ADDENDUM 5

BID TITLE: File No. 55-24 Green Road Pump Station

GREEN ROAD PUMP STATION– FILE NO. 55-24

CWD NO:
 SHEET NO: **E-12**

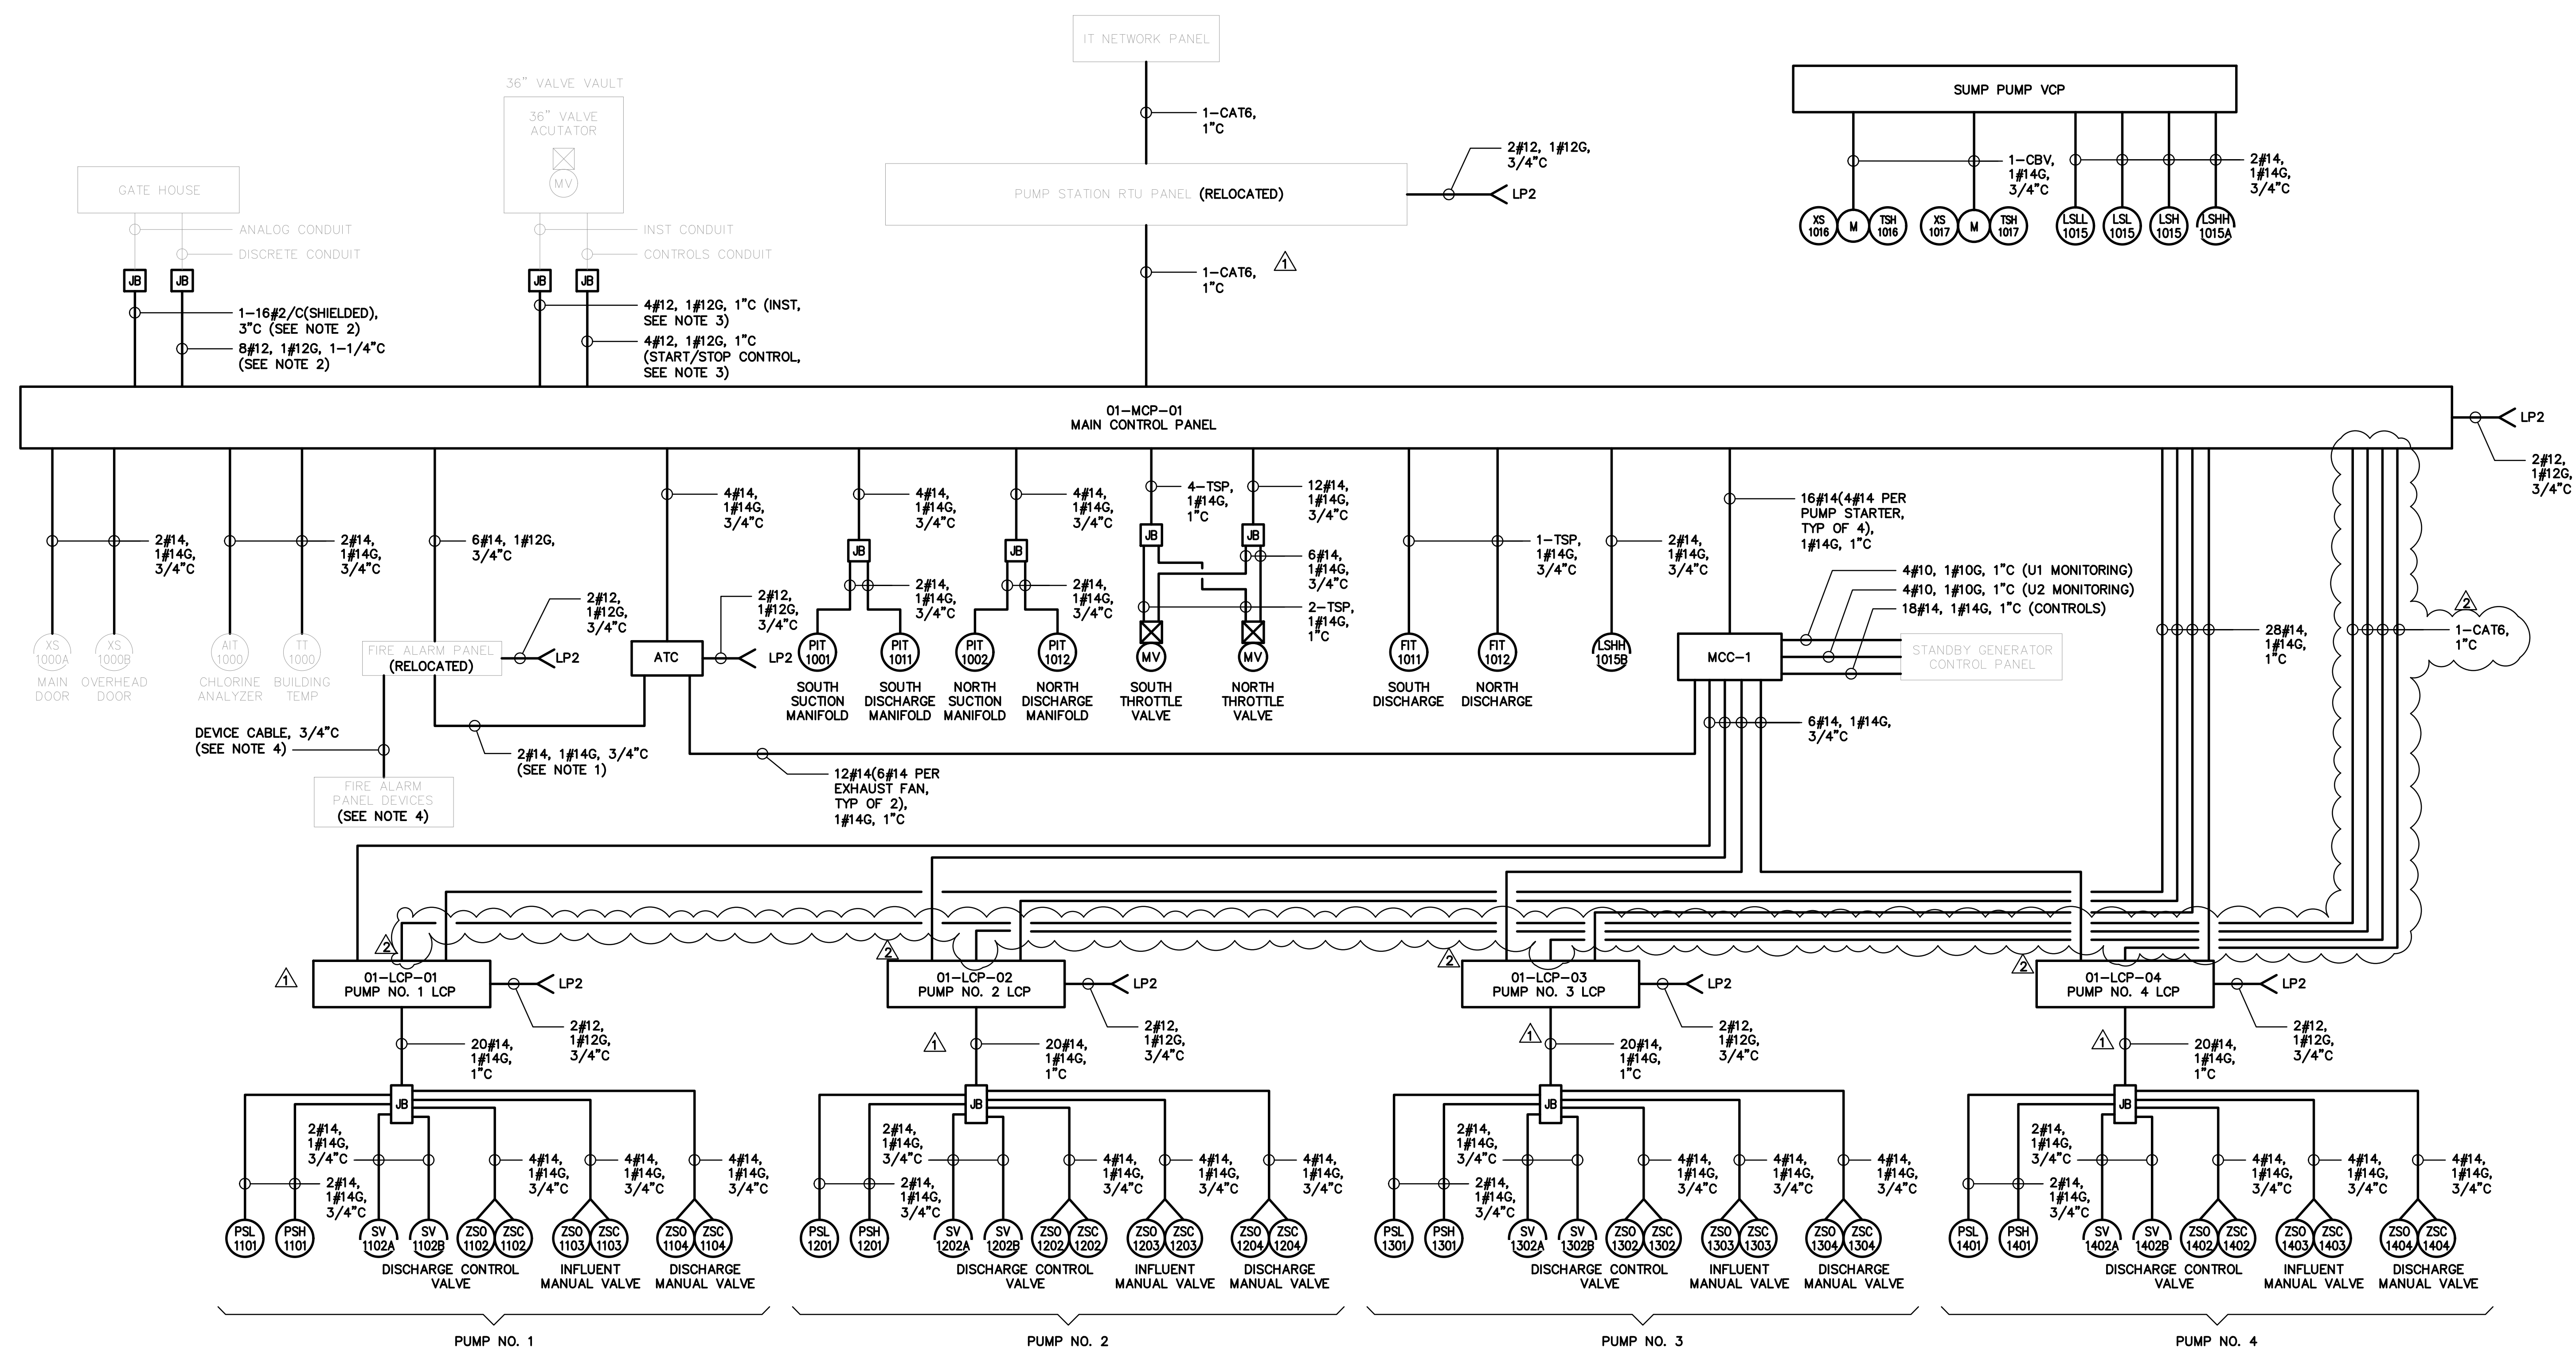
1. C-01 - Showing approximate routing of gas service.
2. C-03 - The gate detail was revised to reflect an ornamental security gate instead of a chain link gate, to match the rest of the existing gate.
3. I-05 thru I-10 and I-20 - Revised to include an intermediate position limit switch on the discharge check valves, and to include check valve closed as a start permissive for the pumps.
4. E-12 - Revised to add a CAT6 cable from each pump local control panel to the master control panel.

28. On sheet, E-12, Note #4 states the contractor is responsible for field verifying quantities of fire alarm devices and reworking all existing fire alarm conduit and cable. Since there are no more site visits, can the locations and quantities of these devices be located on the drawings to allow for an accurate and competitive bid?

29. On sheet, E-12, Note #2 states that from the junction box to the Gate house is all existing cable & conduit. Can you please provide a location of this existing junction box that leads to the gate house?

Answer: Contractor scope of Work is as stated in the Contract Documents; to field verify the existing FACP devices. Existing fire alarm control system generally includes 3-4 smoke detectors in the main pump room, 2-3 audio/visual notification devices on the building exterior at the manddoors. Final quantity and location to be verified by Contractor.

Answer: Junction boxes proposed for the Gate House are proposed new. Provide new junction boxes on the exterior wall to allow for splice connections to the existing conductors.

Answer: Junction boxes proposed for the 36" Valve Vault are proposed new. Provide new junction boxes on the exterior wall to allow for splice connections to the existing conductors.
